WELDONE APPARELS LTD.

Baraidrhalae, Sreepur, Gazipur

Observations

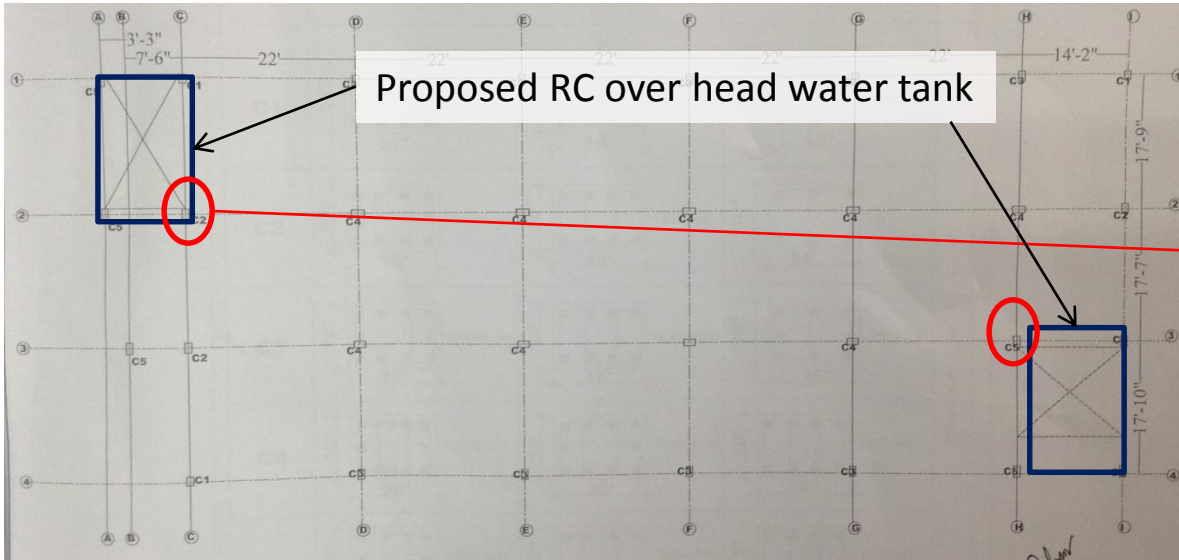
Proposed 4-storey construction with RC water tank will cause high column stresses

Proposed 4-storey construction with RC water tank will cause high column stresses

Item No.	Observation	Recommended Action Plan	Recommended Timeline
1	No clear connection method to tie toilet/ stairs area to main structure	Building Engineer to review structural design of toilet area.	6-weeks
2	No clear connection method to tie toilet/ stairs area to main structure	Carry out remedial work to slab edge as advised by Engineer in advance of construction of stairs/toilet area.	6-weeks
3	Standing water on 1st floor slab	Standing water to be removed from slab.	6-weeks
4	Proposed 4-storey construction with RC water tank will cause high column stresses	Building Engineer to review design, loads and columns stresses in area identified above.	6-months
5	Proposed 4-storey construction with RC water tank will cause high column stresses	Verify insitu concrete strengths either by 100mm diameter cores or existing cylinder strength data for columns under water tanks	6-months
6	Proposed 4-storey construction with RC water tank will cause high column stresses	Prepare loading plans based on column capacity and floor capacity.	6-months
